Top layer

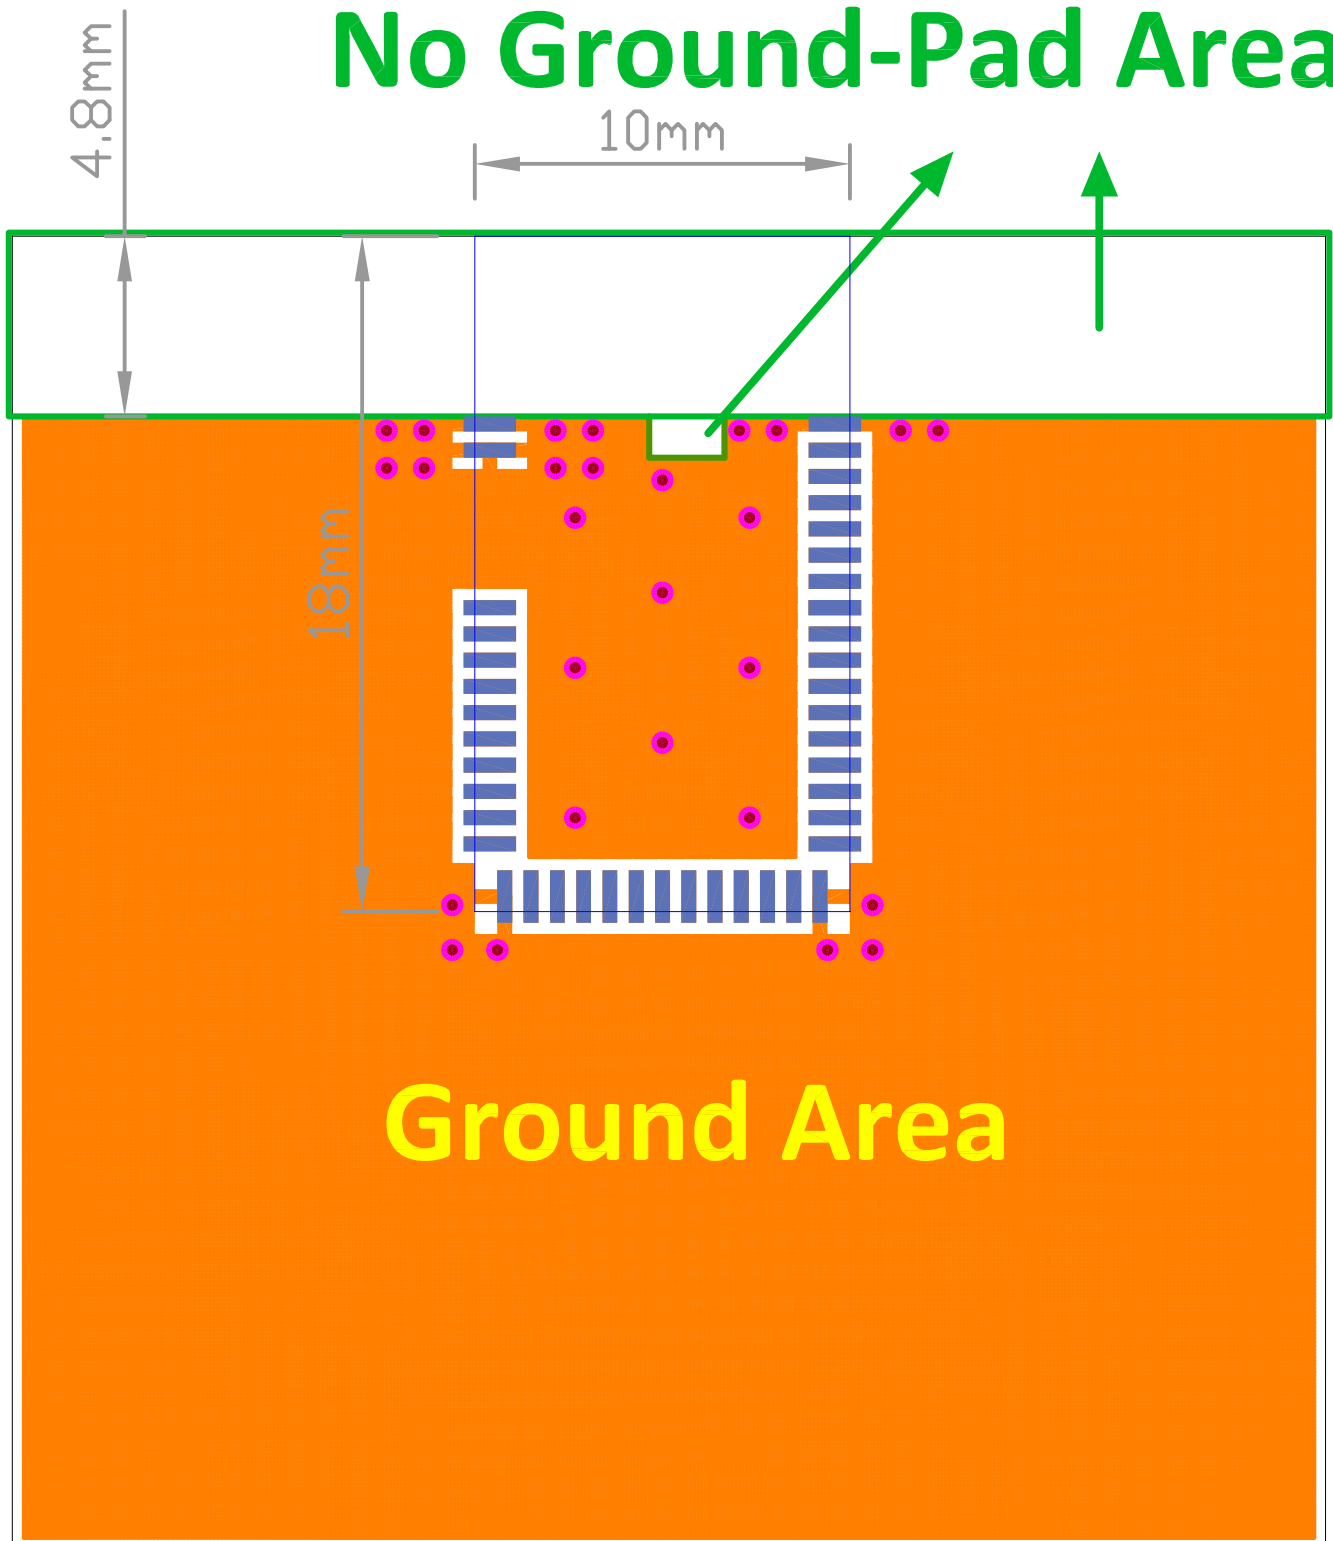
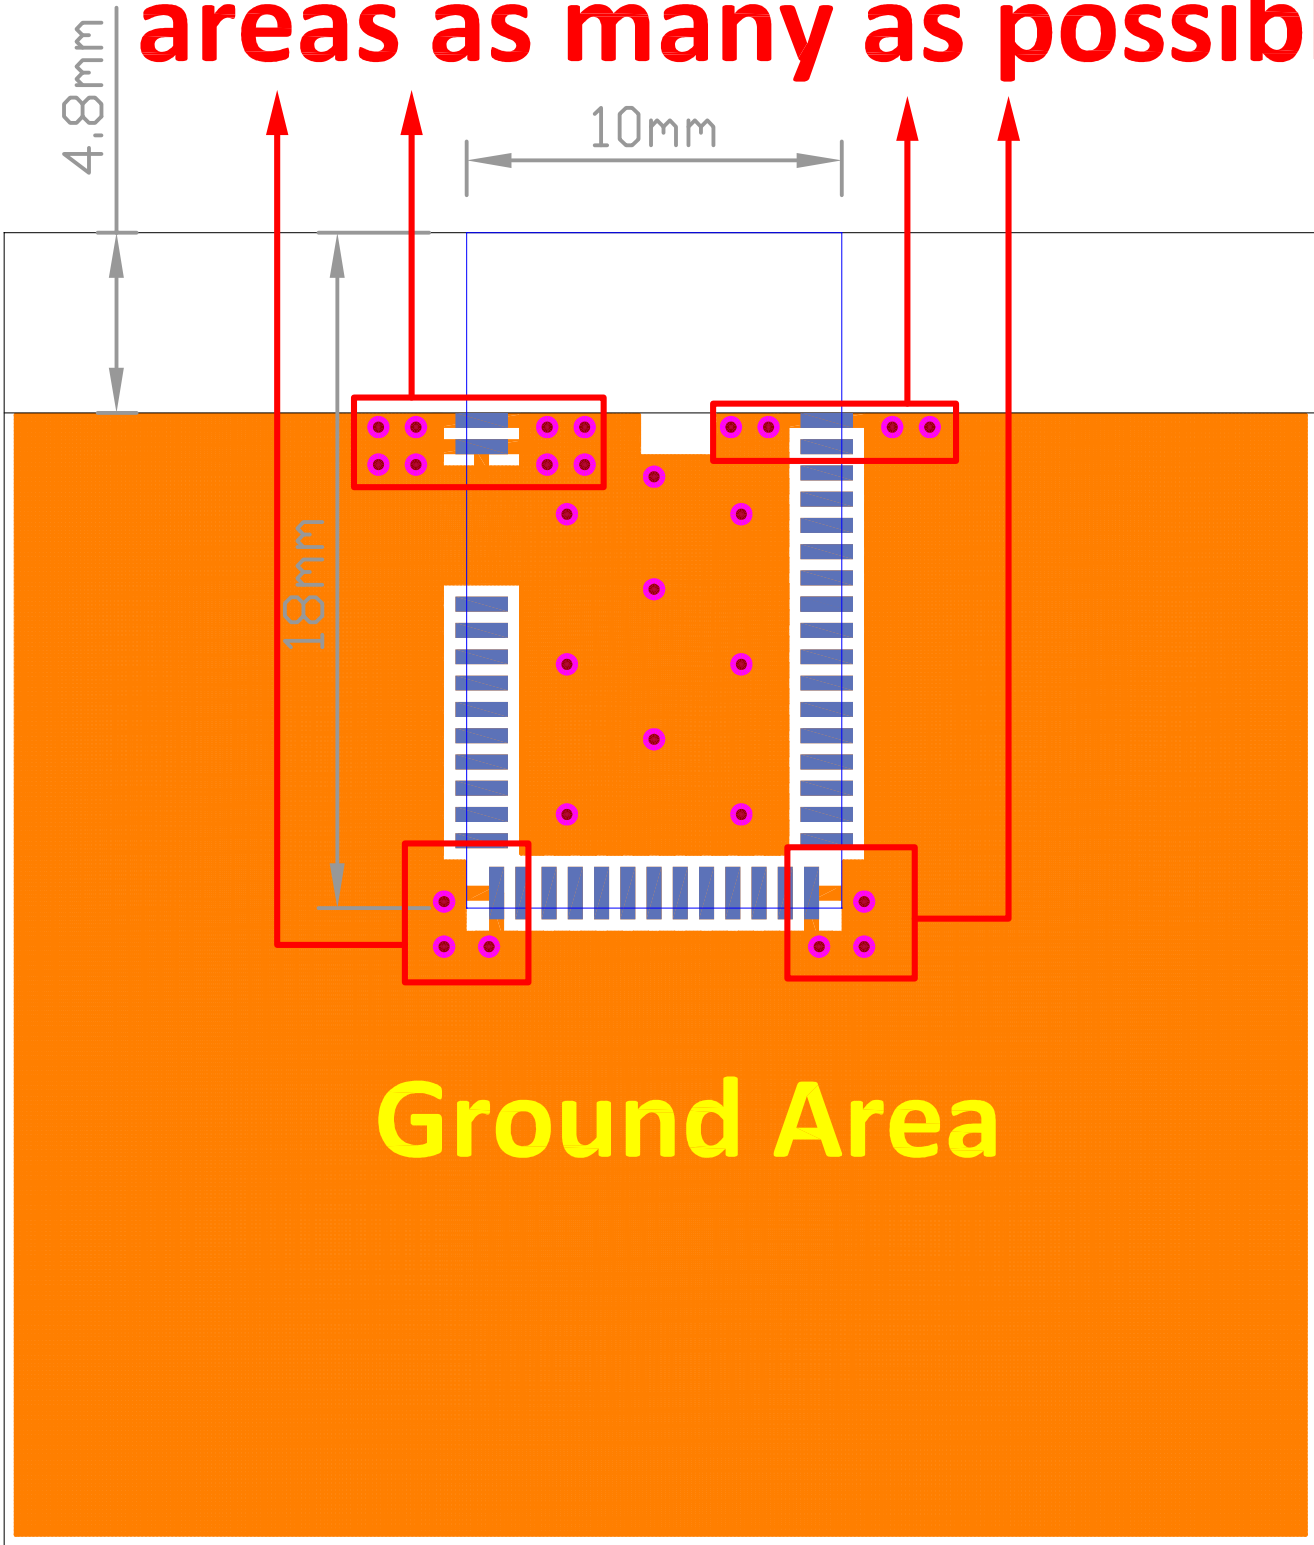
Please add via holes in these areas as many as possible

Bottom layer

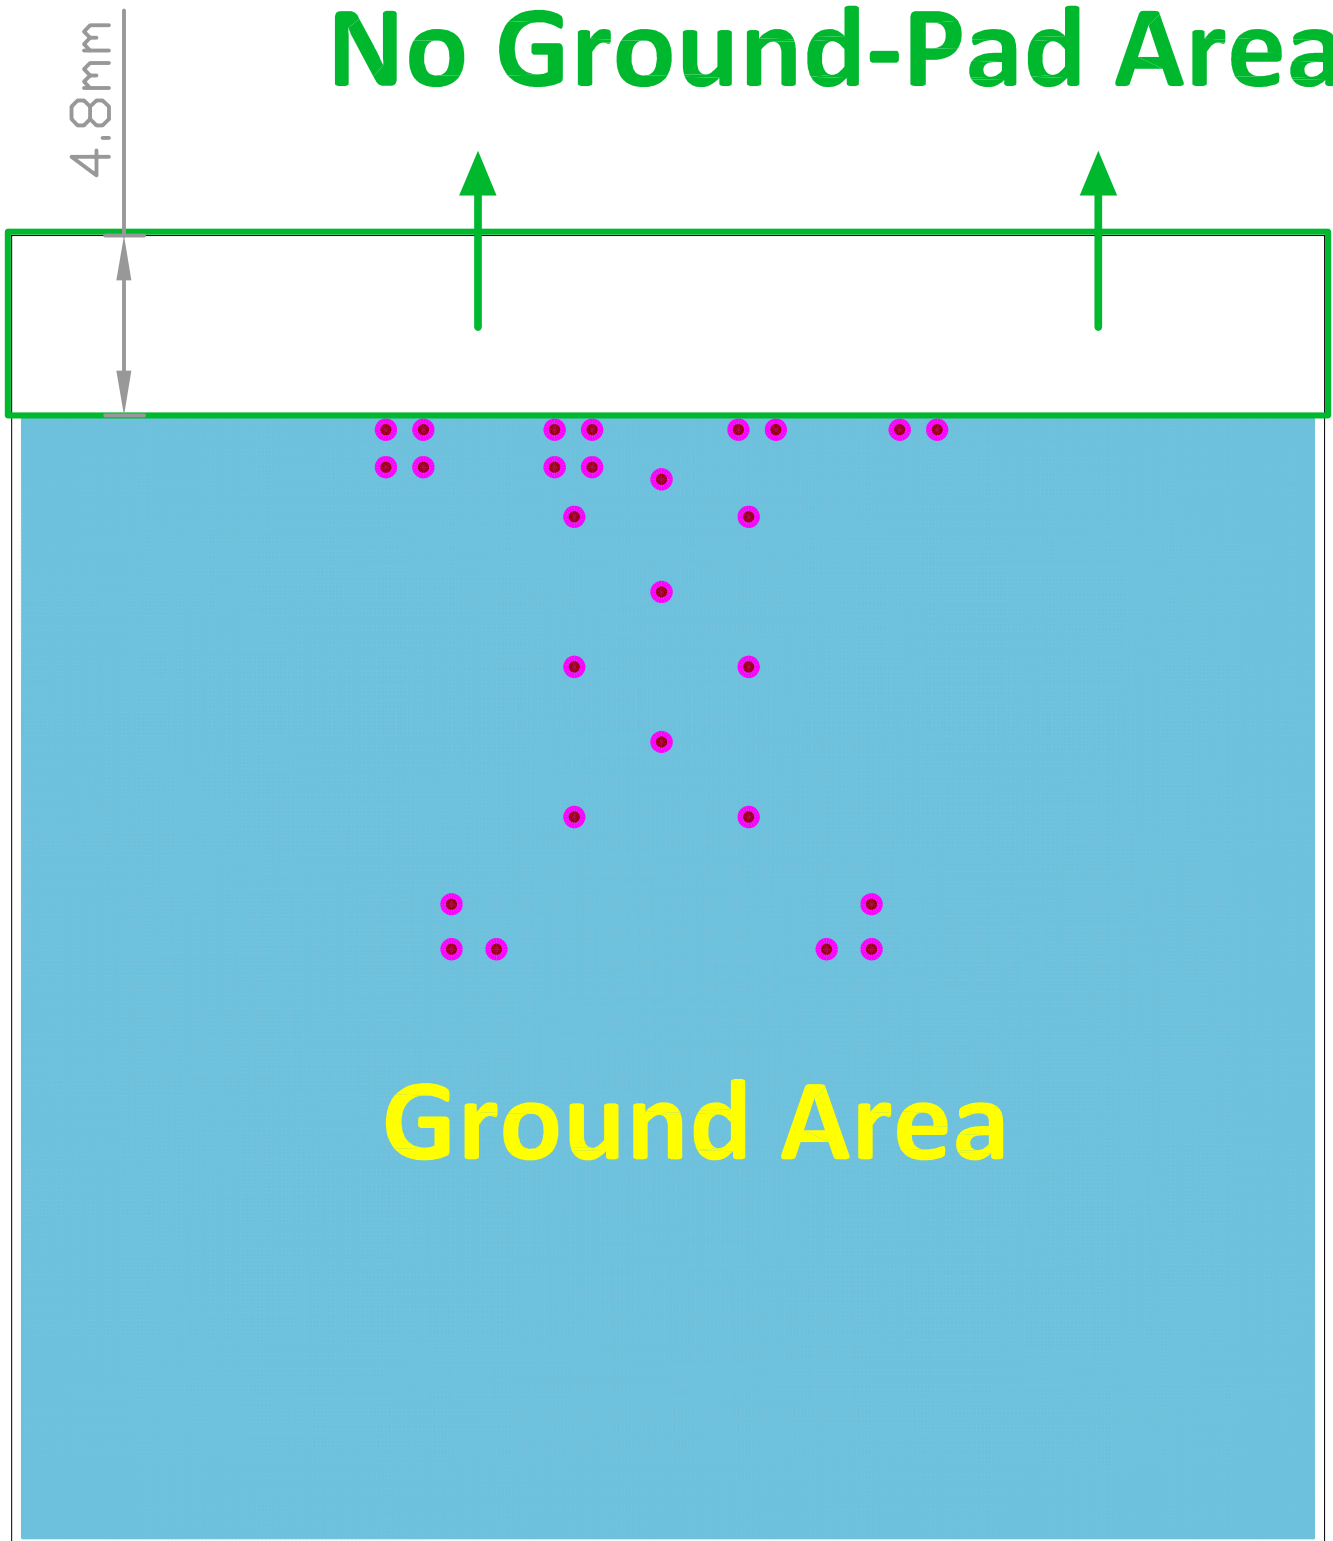
No Ground-Pad Area
